Alpine Construction, LLC
Erosion Prevention & Sediment Control Plan

Bennington BRF 1000 (16)
Prepared by

Vermont Agency of Transportation

October 27, 2014
Revision January 27, 2015

PROJECT NAME:	BENNINGTON	PLOT DATE:	8/7/2014
PROJECT NUMBER:	BRF 1000(16)	DRAWN BY:	J. DAVIS
FILE NAME:	z88j087bdr_eroC.dgn	CHECKED BY:	D. BRYANT
DESIGNED BY:	J. DAVIS	SHEET	58 OF 75
EPSC SITE PLAN

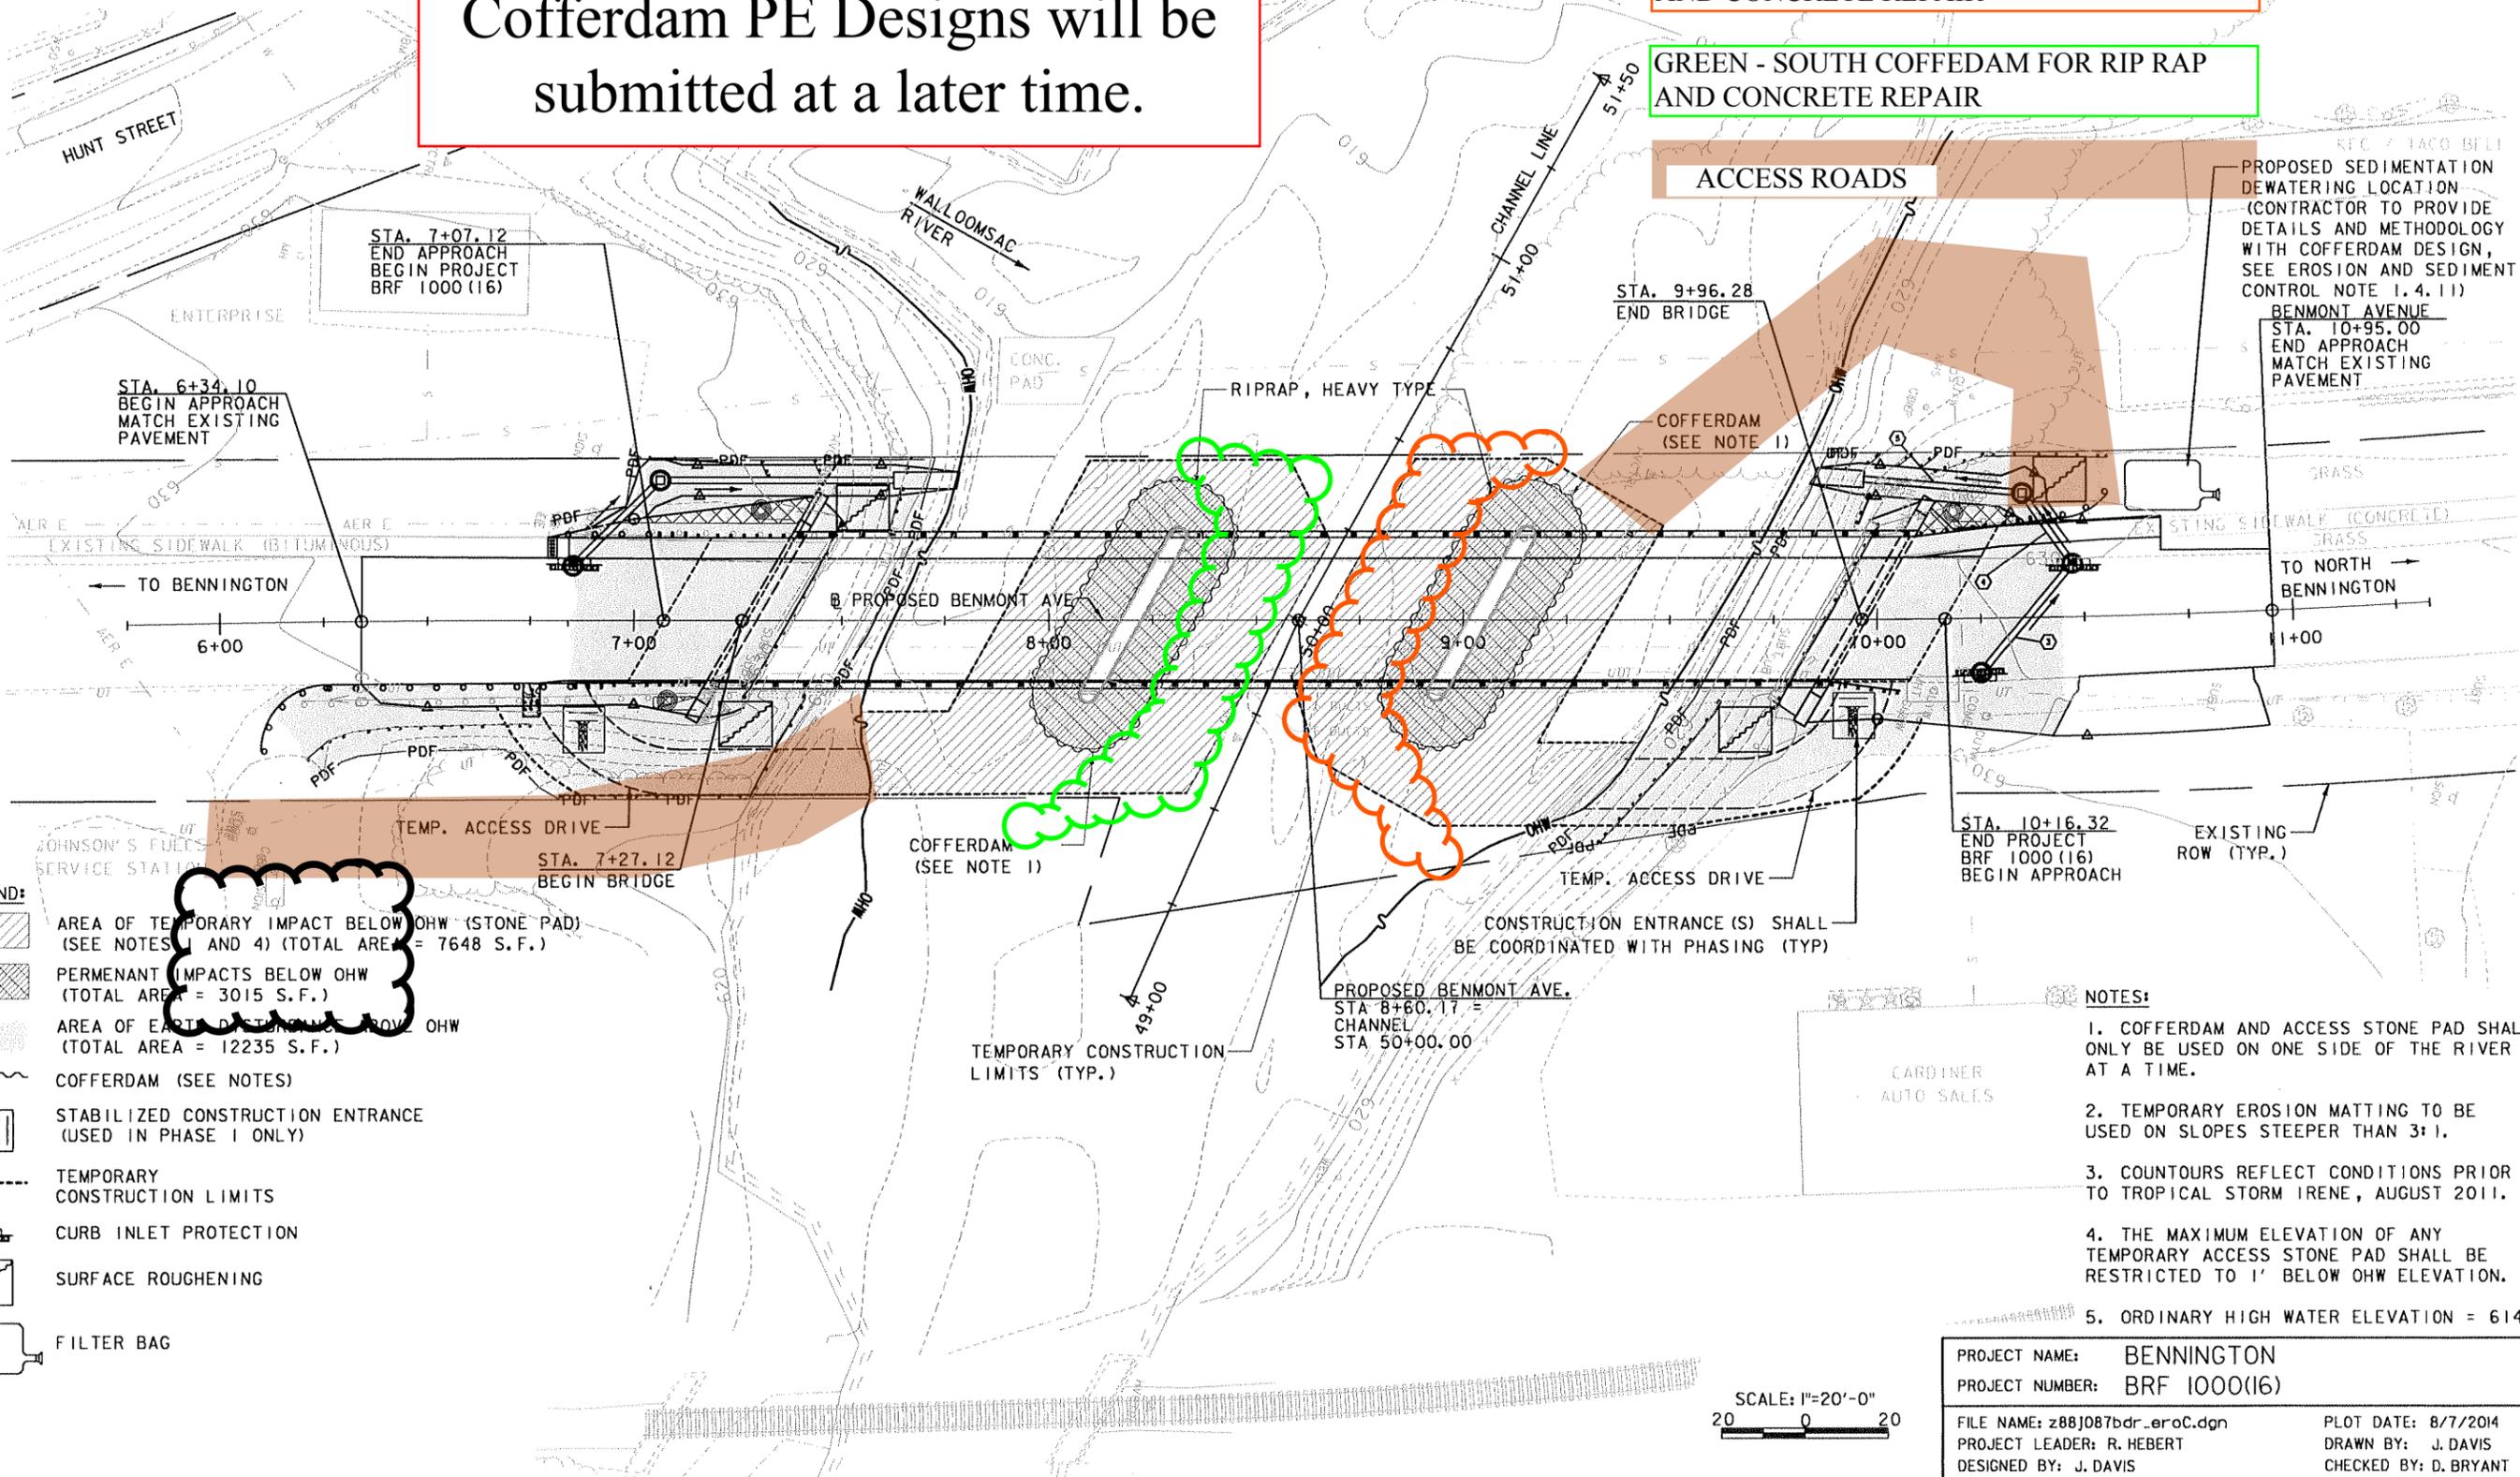
A stone access road will be installed on the northwest side of the project as shown on the attached plans in lieu of the northeast side the bridge to reduce impacts to an adjacent business. The northwest access road was reviewed by the COE and an amendment authorizing the change from the original plan was issued and is included as Appendix 6.

PROJECT NAME: BENNINGTON
 PROJECT NUMBER: BRF 1000(16)
 FILE NAME: z881087bdc-ppc.dwg
 PROJECT LEADER: R. HEBERT
 DESIGNED BY: J. DAVIS
 CHECKED BY: D. BRYANT
 SHEET 58 OF 75

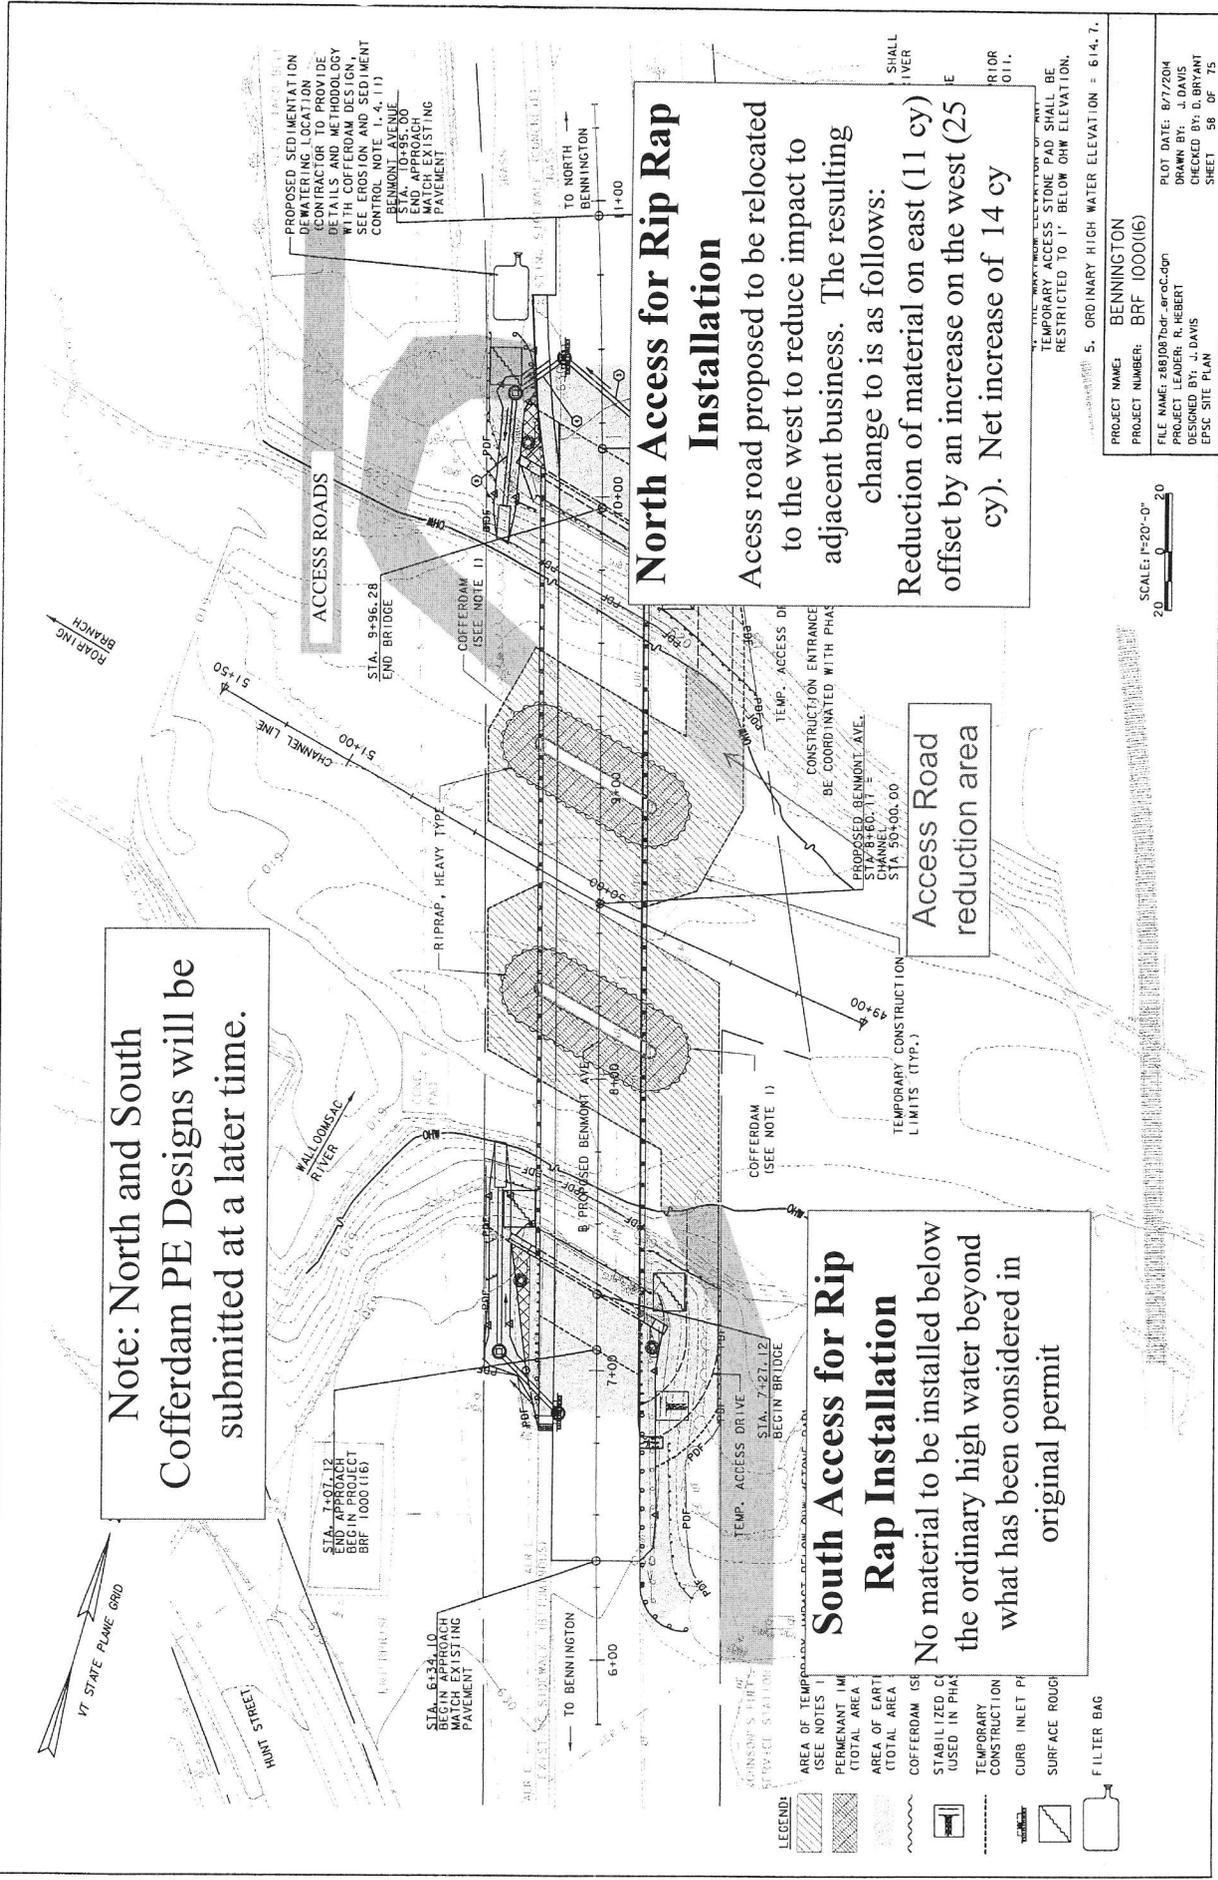
North Access for Rip Rap Installation
 Access road proposed to be relocated to the west to reduce impact to adjacent business. The resulting change to is as follows:
 Reduction of material on east (11 cy) offset by an increase on the west (25 cy). Net increase of 14 cy

We have also added the following special condition to the permit to ensure the potential for flooding during unexpected high flows is minimized to the extent practicable: The maximum surface elevation of any temporary cofferdam and/or access pad/road shall be 1' below the OHW elevation.
